# AQUALLIANCE

April 22, 2022

Re: Colusa Subbasin Groundwater Sustainability Plan

These comments on the December 2021 Colusa Subbasin Final GSP (Colusa GSP) are being provided to support our recommendation that the California Department of Water Resources and the State Water Resources Control Board find that the GSP is incomplete because of multiple deficiencies and the overall failure of the document to comply with the statutory and regulatory requirements of the SGMA and the Water Code. These comments are supplemental to AquAlliance's previous comments provided on the September 2021 Draft Colusa Subbasin GSP, which are attached in Final Colusa GSP in Appendix 2B-2 (pdf pp. 606 to 662). The proposed sustainable management criteria presented in the Colusa GSP fail to demonstrate as required by SGMA that the goal of groundwater sustainability is achievable and will occur within 20 years of GSP adoption to prevent: (1) chronic lowering of groundwater levels, (2) reduction of groundwater storage, (3) degraded water quality, (4) inelastic land subsidence, and (5) depletions of interconnected surface waters. The Final Colusa GSP fails to protect the beneficial uses for all users of gr

Figure 4-4  
**Land Subsidence Monitoring Network**  
 Colusa Groundwater Authority  
 and Glenn Groundwater Authority  
 Colusa Subbasin  
 Groundwater Sustainability Plan

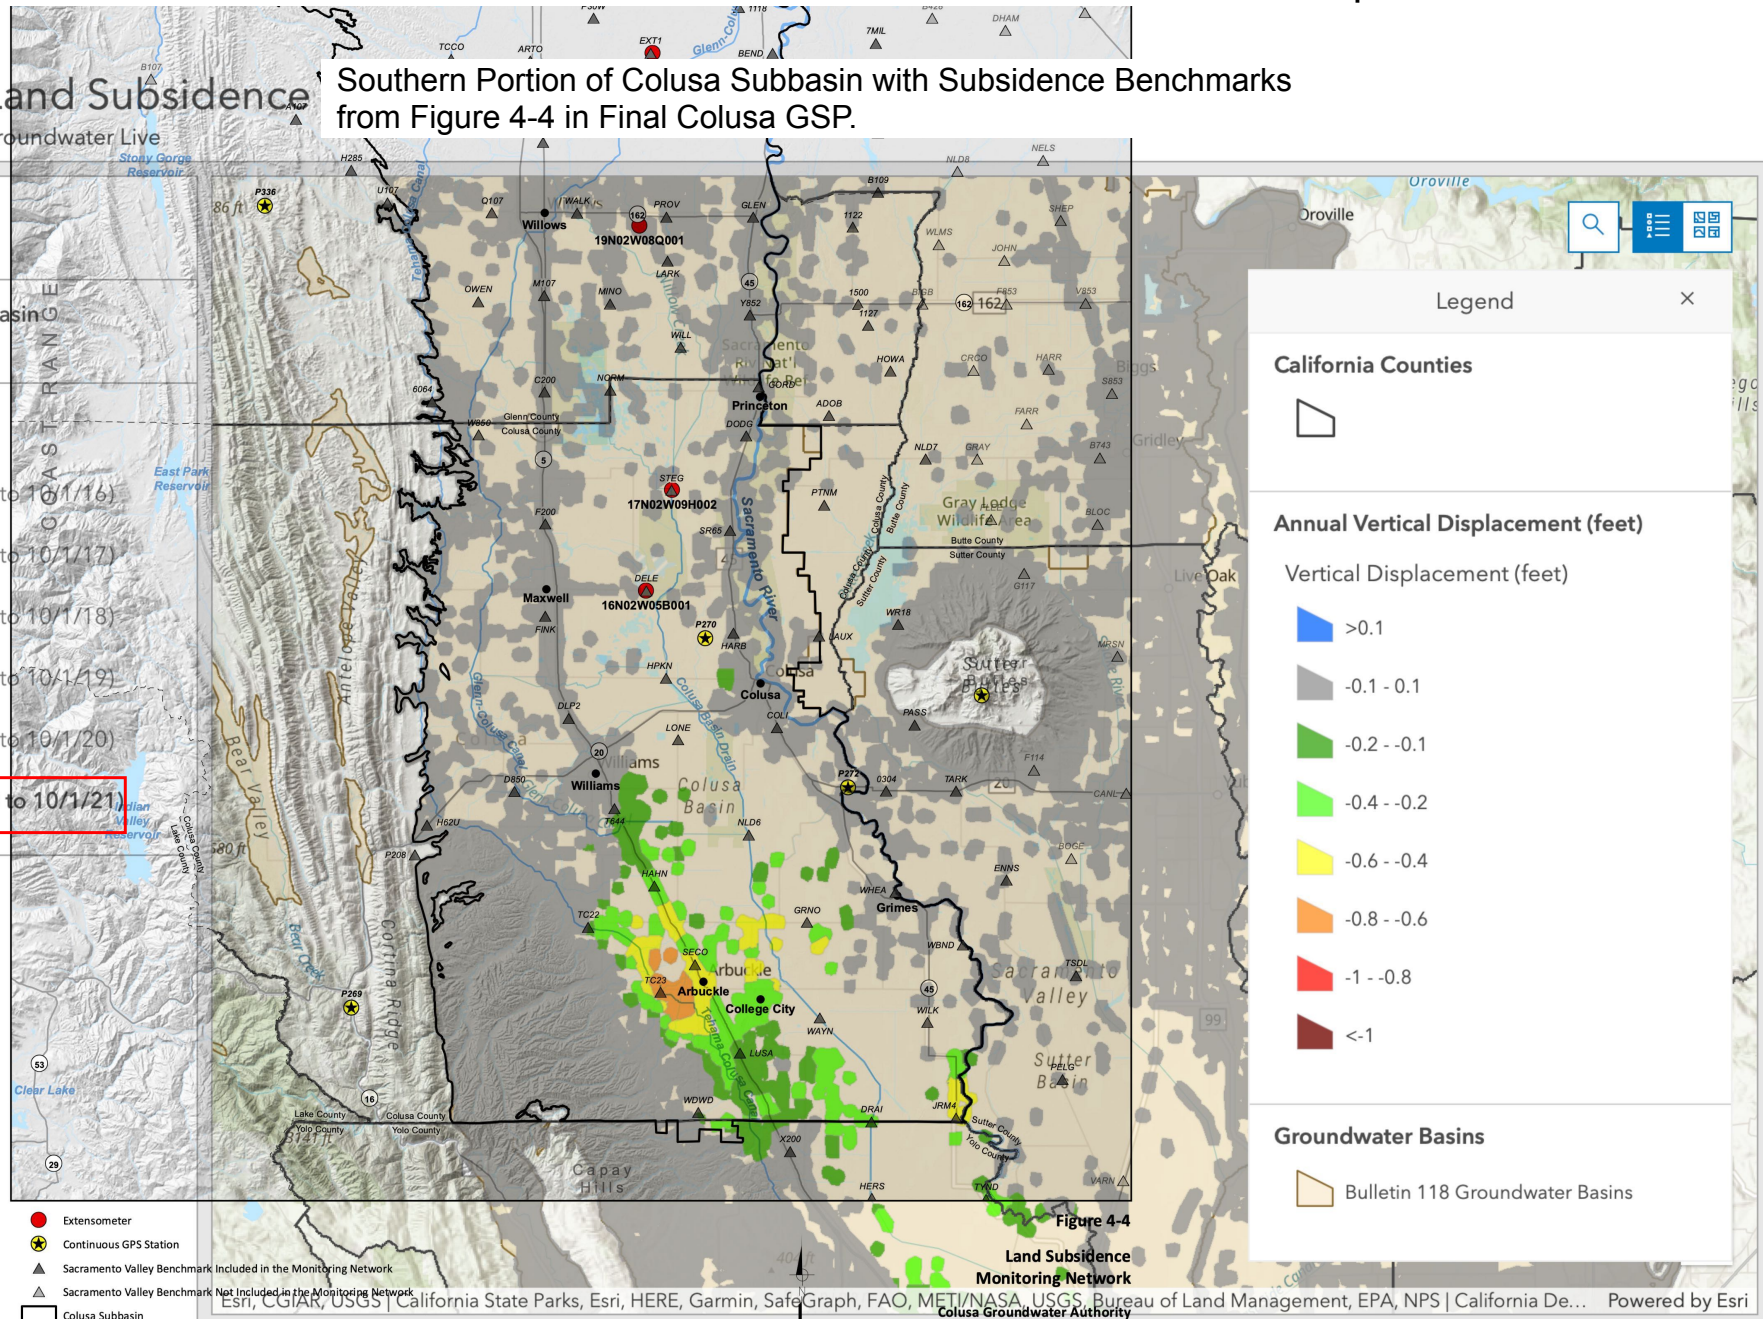
p) The Colusa GSP sets the MO and MT rates for inelastic subsidence at 0.25 feet per 5 years, and 0.50 feet per 5 years, respectively, Table 5-1 and Sections 5.4.5.1 and 5.4.5.2 (pp. 5-18, 5-28 and 5-29, pdf pages 282, 292 and 293). The current conditions in the subbasin appear to be exceeding these values. The latest October 2020 to October 2021 InSAR measurements of vertical displacement, or subsidence, in the Sacramento Valley measured declines in land surface elevation around Arbuckle and Artois (AquAlliance Exhibits 11 and 12).

The Colusa GSP needs to provide additional information and reasoning for: (1) why the existing subsidence isn't considered an undesirable result; (2) why the -0.1 feet per year of InSAR vertical displacement shouldn't be considered undesirable; (3) why 20% of the subbasin needs to be in significant subsidence before management actions need to be taken; (4) why subsidence impacts need to be averaged over 5 years when other MT are based on 2 years (24 months); (5) what critical infrastructure has already been harmed by the current areas of subsidence; (6) what amount of additional land subsidence will cause harm to other critical infrastructures; and (7) why the MT for land subsidence doesn't take into account the amount of differential settlement that critical infrastructures and domestic structures in the subbasin can tolerate.
